Page 1: DRC Site Plan - Applicant Information Sheet

THE GALLERIA COMMUNITY
FORT LAUDERDALE, FLORIDA

DEVELOPMENT REVIEW COMMITTEE (DRC) COMMENT REPORT

Request: Site Plan Level IV Review: 1250 MF Units, 163 Hotel Rooms, 105,796sf Office Use, 13,200sf Restaurant Use & 4000sf Financial Institution Use / Rezoning with Residential Flex Allocation and Parking Reduction Request

SHEET NO.:
A1-100

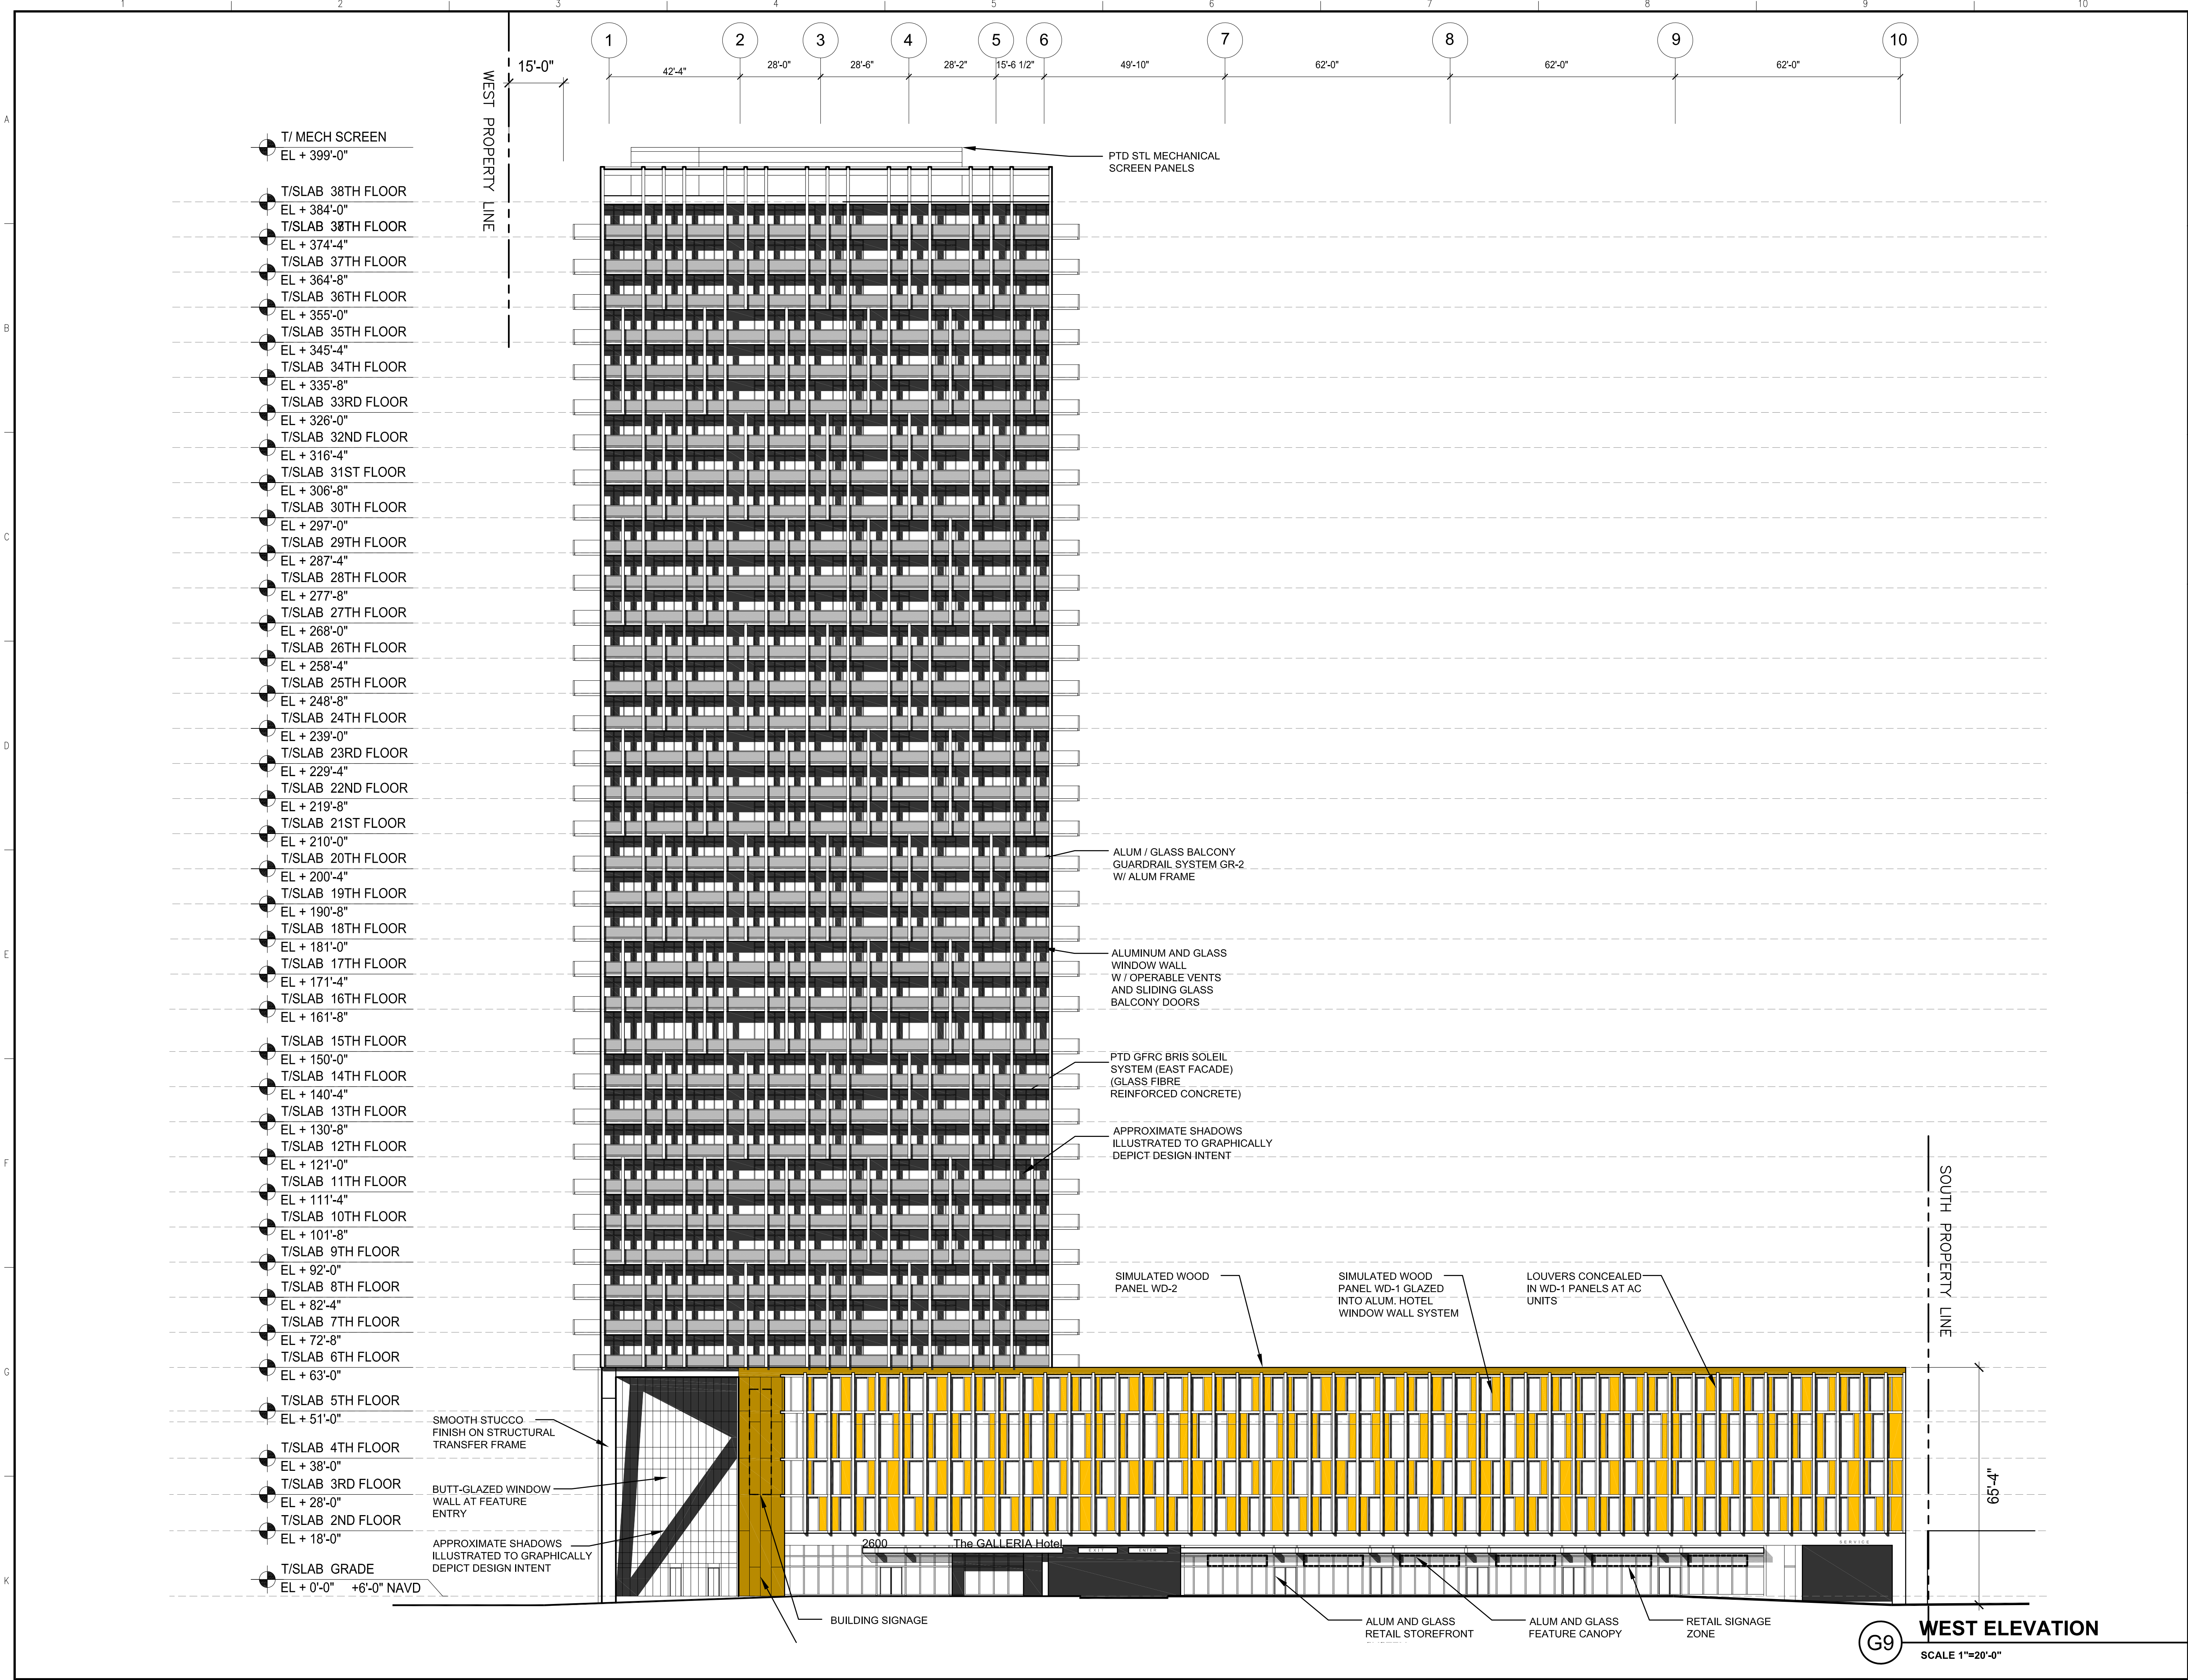
17. Middle River Drive & N.E. 9th Street Intersection – Complete ‘Truck Circulation Plan’ by showing truck turning template for all major movements (including southbound to eastbound).

20. Show sight triangles at the intersection of driveways with the streets, per ULDR 47-2.2.Q, for safe and adequate access of drivers and pedestrians.

21. Show all radii for the proposed islands and pavement areas on the site plan.
22. Drainage pipes missing to drain structured soil at proposed planting areas, which shall be coordinated with the Landscape Plans.

24. Provide a turning movement template on the site plan showing how a WB-50 truck circulates on site to access and to depart the loading zone location.

32. Show on the site plan how the vehicular conflicts at the intersection of the "Mall & Tenant Parking Entry" and the two existing "Mall Parking Entrance" along the north of the parking will be resolved. Traffic control devices shall be implemented as appropriate.

41. Show better differentiation between vehicular areas (drivable surfaces) and pedestrian walkway areas.
